**Full Planning Approval Consultation**

**Application Number:** 243229

**Site Address:** 109 Victoria Road, Wargrave, Wokingham, RG10 8AG

# MEMORANDUM

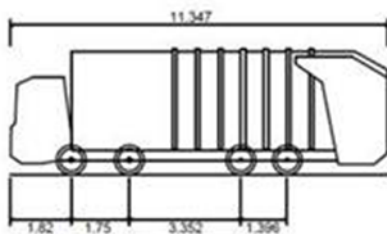
Swept path analysis for a refuse vehicle and fire tender should be reviewed to accommodate any revisions to the junction layout and shall include assessment of existing on-street parking on Victoria Road, opposite the access (see photo).
